Form 3160-5  
(June 2019)

**SUNDRY NOTICES AND REPORTS ON WELLS**  
**Do not use this form for proposals to drill or to re-enter an abandoned well. Use Form 3160-3 (APD) for such proposals.**

Pistolero 15 Fed Com 301H (FKA 301H) API #: 30-025-52550

EOG respectfully requests an amendment to our approved APD for this well to reflect the following changes:

Proposed Wellbore

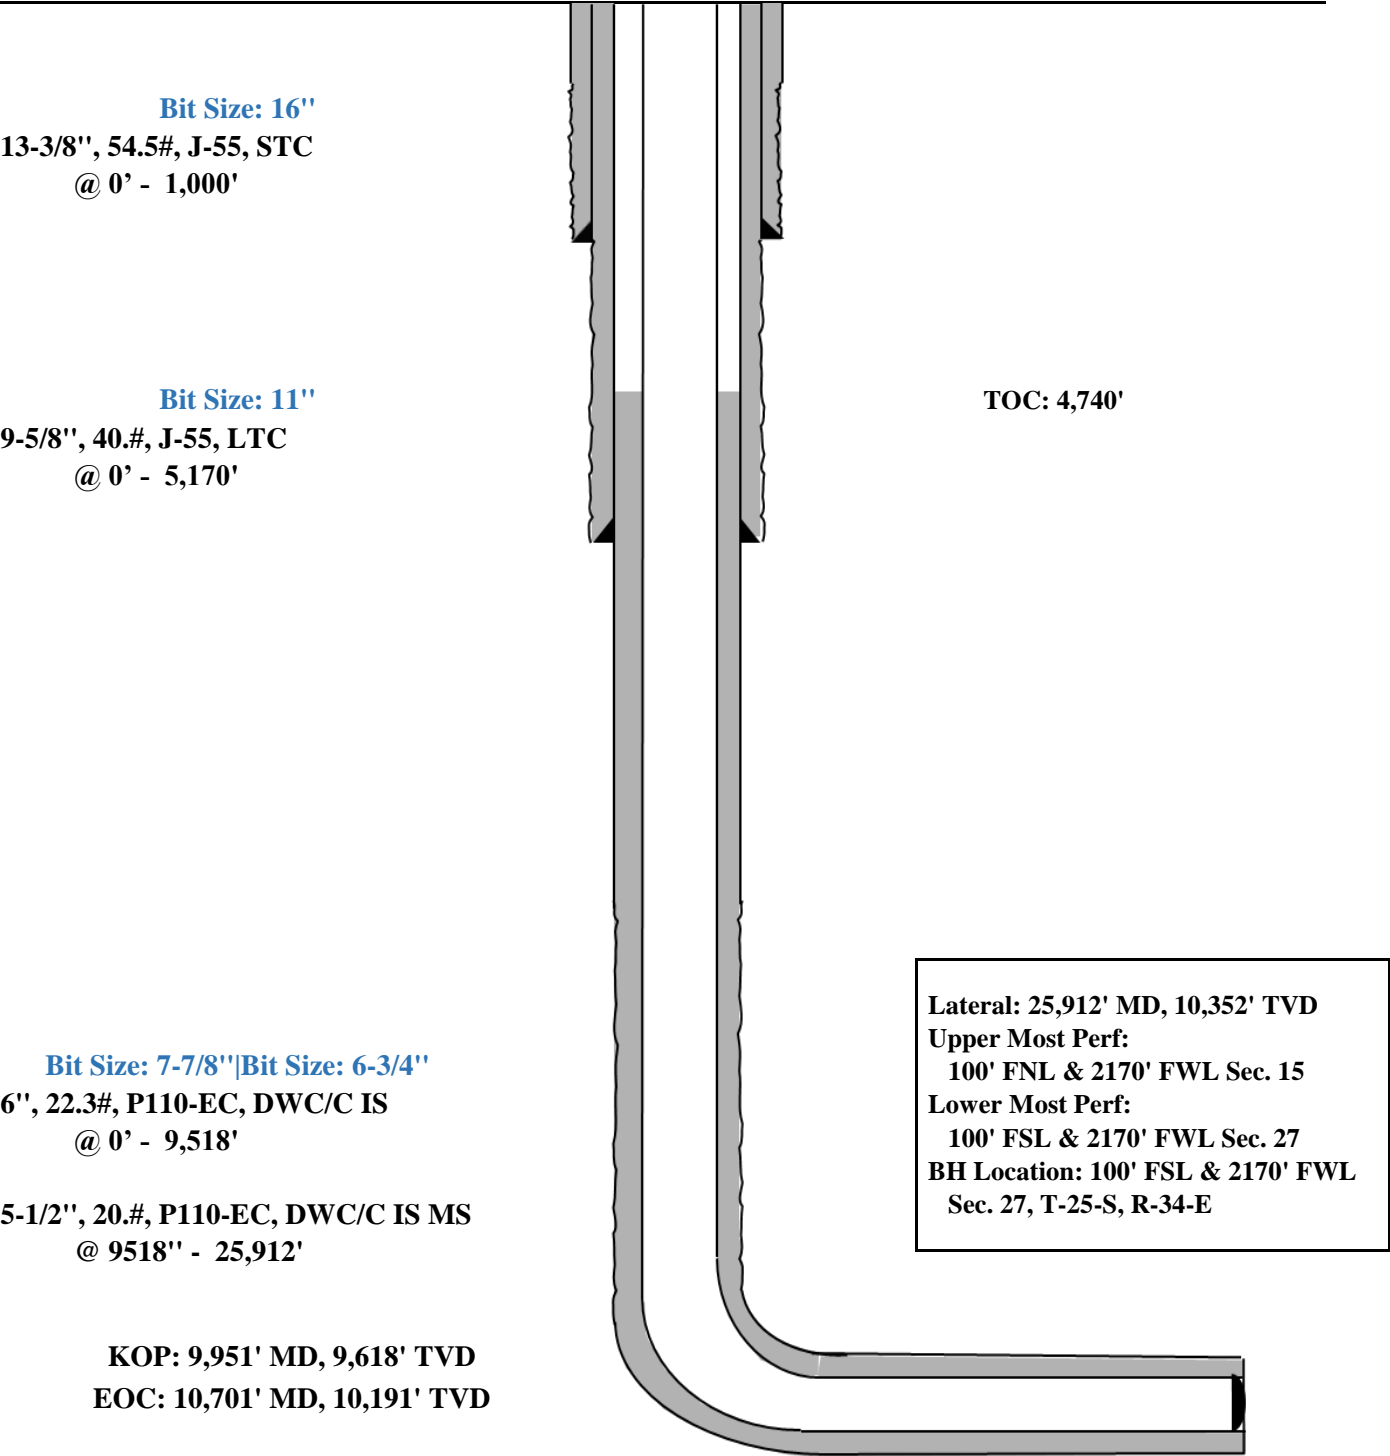
Change name from Pistolero 15 Fed 301H to Pistolero 15 Fed Com 301H.

Change BHL from T-25-S, R-34-E, Sec 27, 100' FSL, 330' FWL, Lea Co., NM, to T-25-S, R-34-E, Sec 27, 100' FSL, 2170' FWL, Lea Co., N.M.

Change target formation to Leonard B.

Update casing and cement program to current design - Batch Sundry ID #2779141

Well Name: Pistolero 15 Fed Com 301H; FKA Pistolero 15 Fed Com 301H

Location: SHL: 341' FNL & 1190' FWL, Section 15, T-25-S, R-34-E, Lea Co., N.M.

BHL: 100' FSL & 2170' FWL, Section 27, T-25-S, R-34-E, Lea Co., N.M.
